Development and Resource Management Department

July 6, 2016
Changes requested by Planning
Commission on July 20, 2016 in red

SUBJECT: DEVELOPMENT PERMIT APPLICATION NO. D-16-031 FOR PROPERTY
LOCATED AT 1161 EAST SHEPHERD AVENUE (APN: 403-021-03)

ARCHITECTURAL SITE PLAN

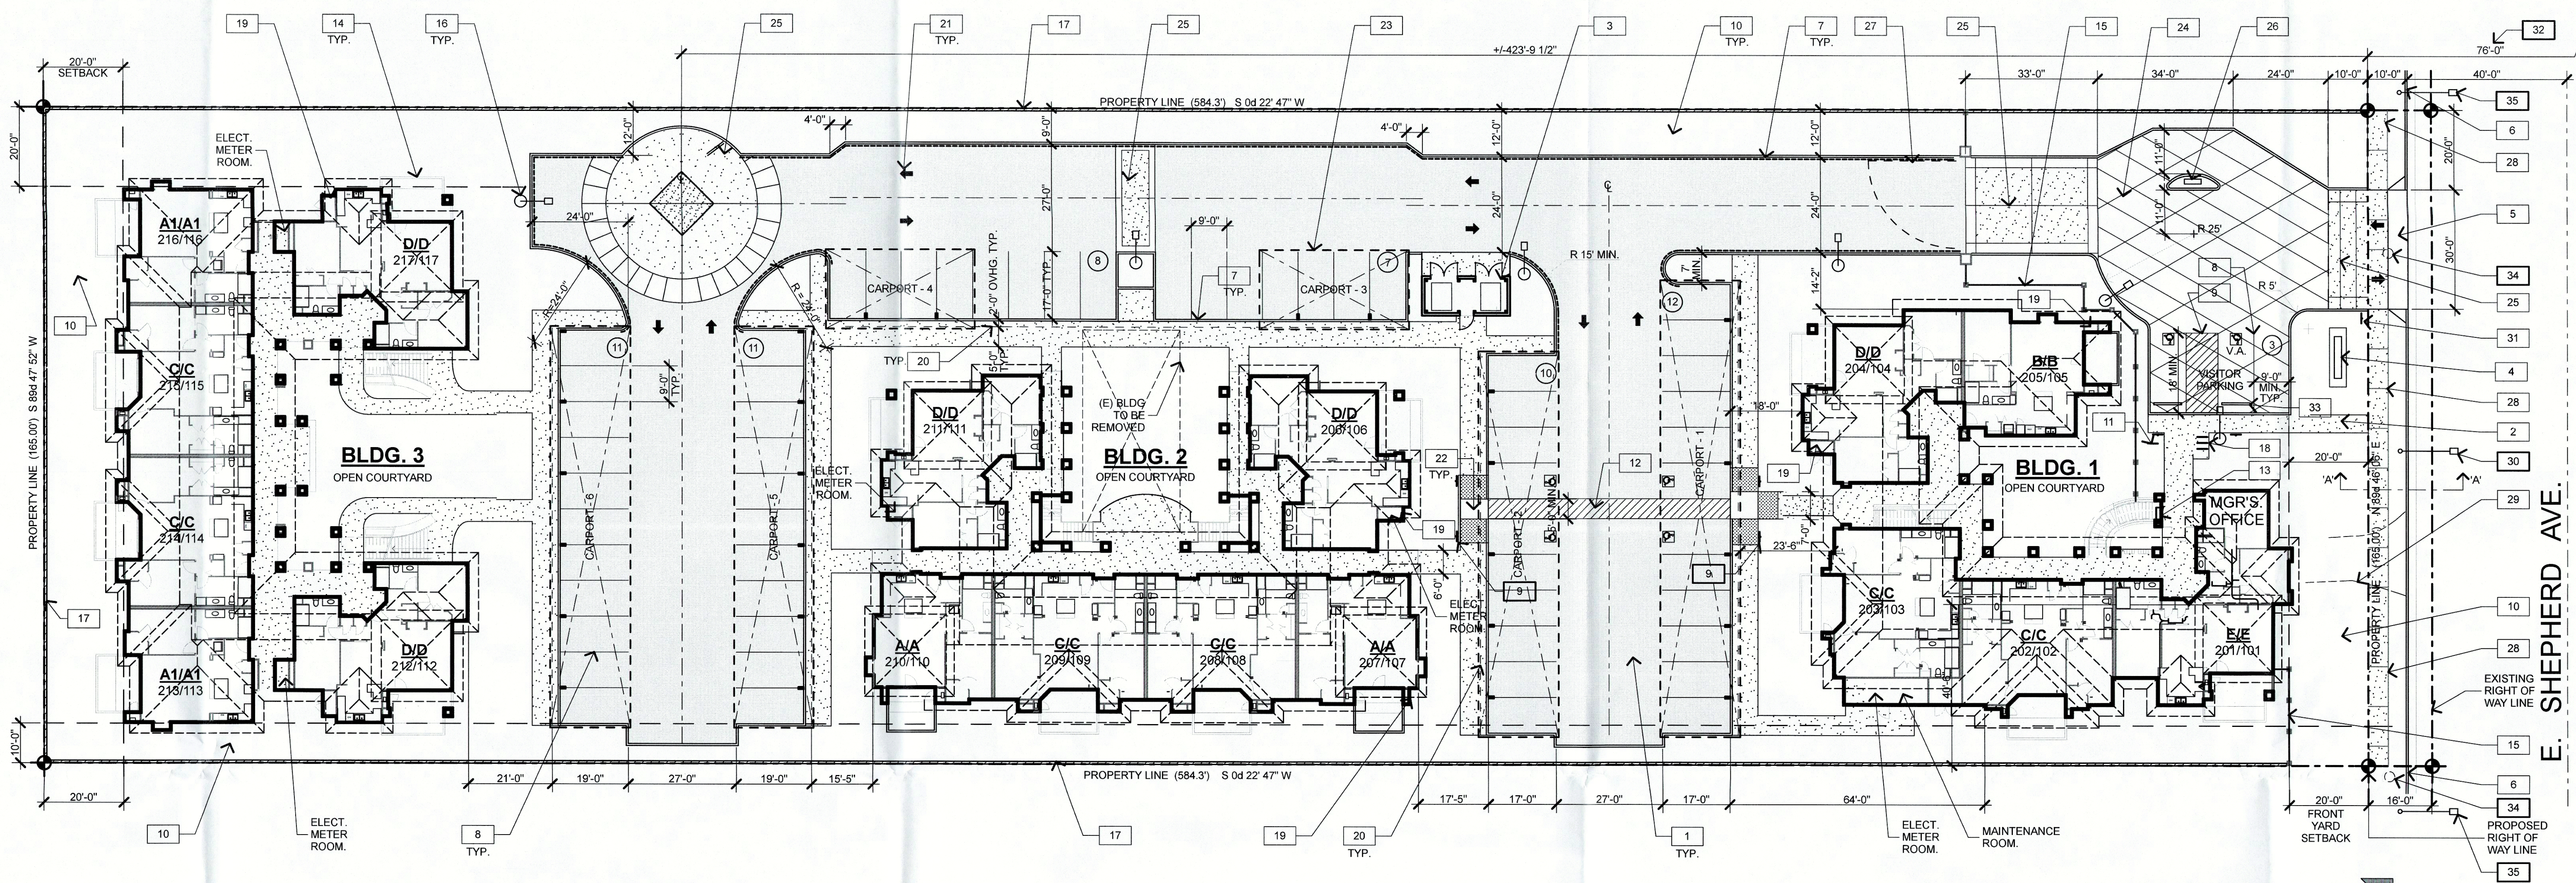
Table with 2 columns: Planner to check when completed, and 1 row: 1. Transfer all red line notes, etc., shown on Exhibits A dated May 20, 2016 and Exhibits B-1, B-2, E-1, E-2, E-3, E-4, E-5, R-1, R-2, R-3, F-1, F-2, F-3, F-4, F-5, F-6, F-7, F-8, and L dated April 5, 2016, to corrected exhibits. Submit the corrected exhibits for further review and approval. Please also review other agency/department comments and revise site plan accordingly. Transfer all comments and conditions on exhibits to the

Required	Table, §15-1003 for RM-1 District: Frontage Coverage = minimum 50% of area between the minimum and maximum front setback area. Lot Coverage = maximum 50% of lot. On-site Open Space = minimum 20% of lot area.
Proposed	Lot coverage of 35.4%, as shown in site plan notes. <i>As a condition of project approval - Provide frontage coverage calculation and illustrate on Site Plan.</i>

Comment	<p>Show typical dimensions of parking stalls on the Site Plan that conform to City Standards – provided.</p> <p><i>As a condition of project approval – Show 10 additional uncovered parking stalls on the Site Plan (may convert the additional covered stalls shown on site Plan).</i></p>

Comment	<i>As a condition of project approval – Show storage areas for each dwelling unit on Site and/or Floor Plans.</i>
ACCESS		
	Required	<p>Pedestrian Access - §15-1004-E, must be provided on-site according to:</p> <ol style="list-style-type: none"> 1. Flexibility Options – applicant to demonstrate that the project meets the following goal: <ol style="list-style-type: none"> a. Provide sufficient opportunities for residents to walk to nearby amenities, services and transit facilities. 2. Certainty Option - <ol style="list-style-type: none"> a. Common entrances to internal pedestrian paths shall be provided at the rate below, with entrances protected by a portico, canopy, or alcove no less than 4-feet deep. ii. No less than 1 per 600 feet of linear street frontage are required outside of priority areas.
		<p>b. Direct entrances to individual dwelling units adjacent to a public street shall be provided at a rate of 1 per 75 feet of linear street frontage.</p>

SCHEMATIC LANDSCAPE PLAN
SCALE: 1" = 20'-0"

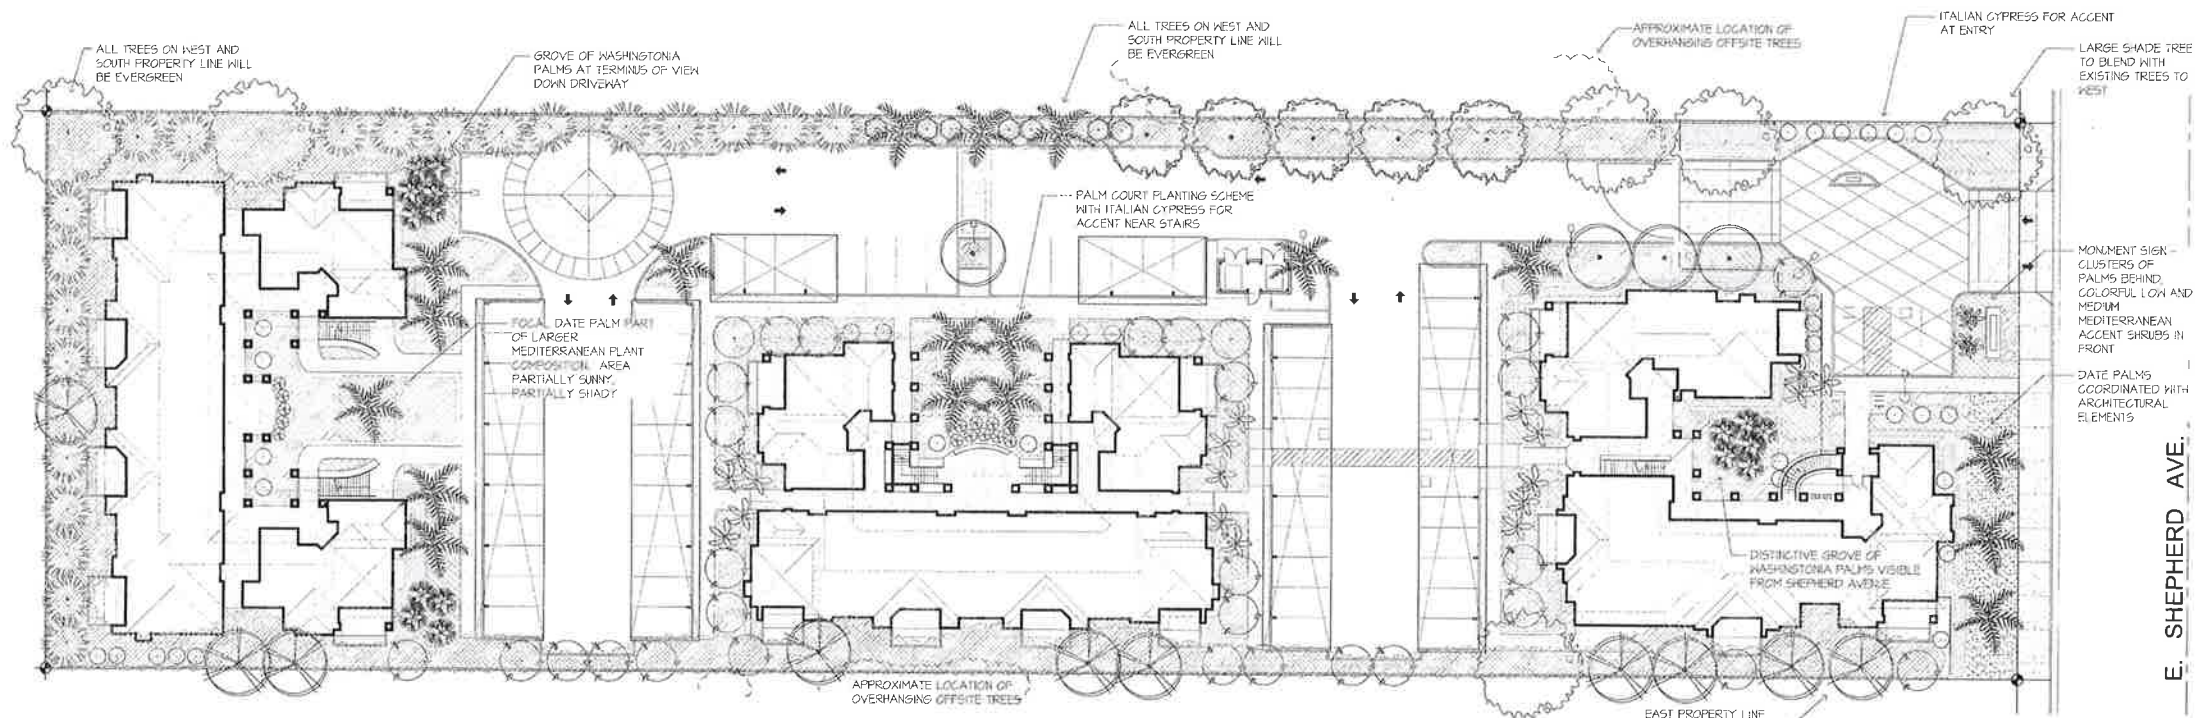
Proposed	Landscape Plan notes show 92 trees, comprised of 25 medium-large and 67 medium tree 'equivalents' (83 small + 51 palm = 134 + 25 = 159 trees total). A total of 68 evergreen trees are shown in the 10-foot buffer measuring 1,312 feet, an average of 1 tree every 19 feet. Another 63 mixed trees are shown in parking areas, with 11 mixed palm trees in courtyards and at the property frontage.
----------	--

- (1) Provide shade calculations on the final Landscape Plan (condition of approval) as a for parking lot shading in accordance with the attached *Development Department, Performance Standards for Parking Lot Shading*, including tree species and tree counts.
- (2) See the attached Notes and Requirements for Entitlement Applications for additional general notes and requirements for development applications.
- (3) Any development agreements, covenants or easements, etc. required for previous development of the project site will be required for review, and must be dedicated and/or recorded prior to any further development approval.
